SUBJECT: Forwards site mod package containing drawings of mods to  
 sampling point for TSC intake ventilation monitor, per  
 discussion during Emergency Preparedness Insp 50-528/87-22,  
 50-529/87-22 & 50-530/87-23.

**FOR INFORMATION ONLY**  
PVNGS  
**SITE MODIFICATION**

This site mod is a partial of PCR 87-HN-001. The scope of work is to relocate the sample point of radmonitor AJSQNRU13A from a point in the duct which does not sample TSC office air during emergency mode to a point of recirculation.

FCR # P-A5194

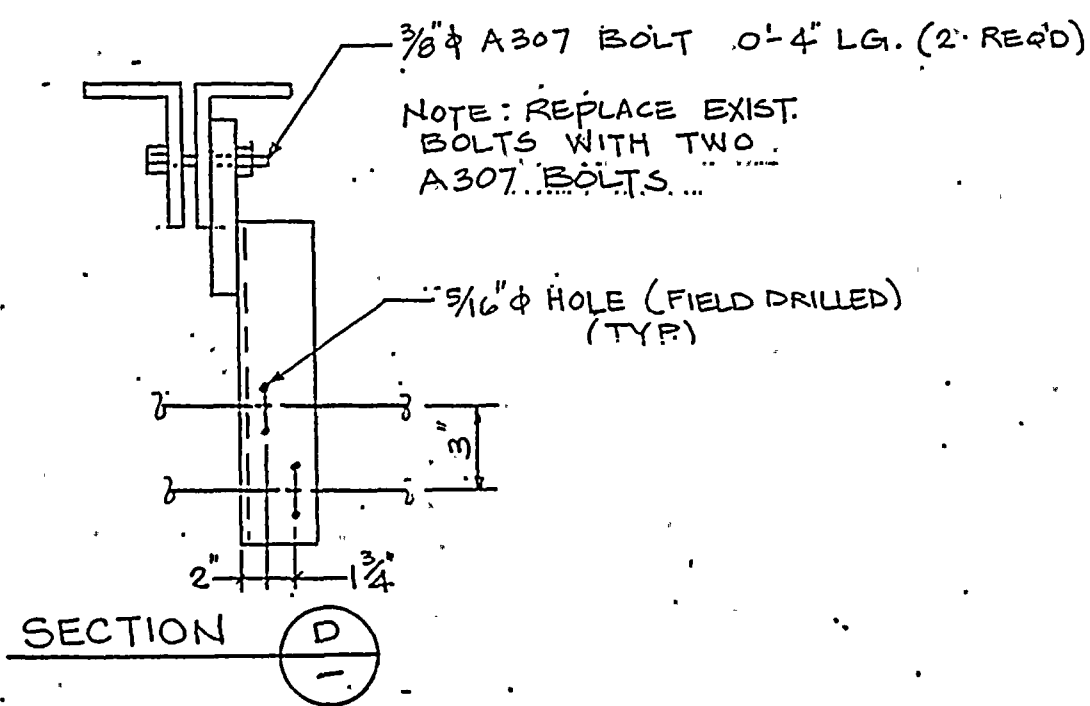
7. Install two pipe supports, each supporting both sample lines in locations as shown on the plan view of drawing AO-P-ZYA-961. These supports shall be fabricated as <sup>was</sup> shown on details 4 & 5 of drawing AO-P-ZYA-962. See Bill of Materials items 6, 7, 8 & 9.

1"  $\phi$  STANDARD U-BOLT  
SEE TYP. U-BOLT  
DETAIL

FCR NO: PA5195 Page 2 of 2

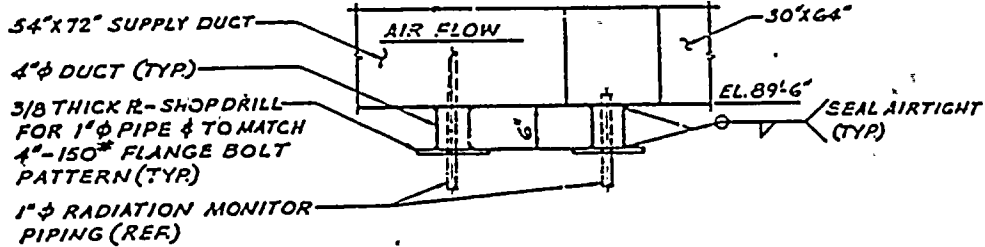
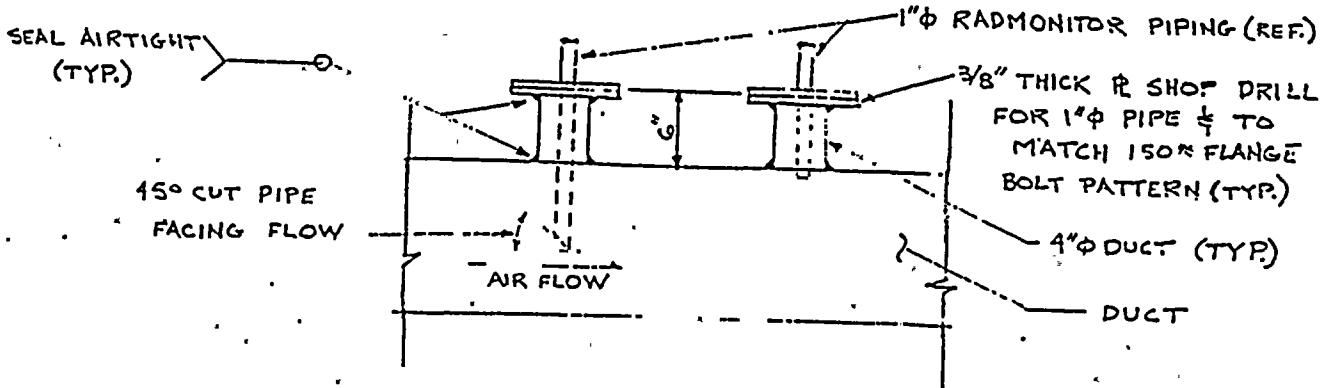
Note, special precautions shall be made in order to assure that the inlet sample probe faces the direction of the air flow as shown on detail 1 to the FCR of drawing AO-P-ZYC-012.

WAS (COORDINATE G-3):

CHANGE TO:
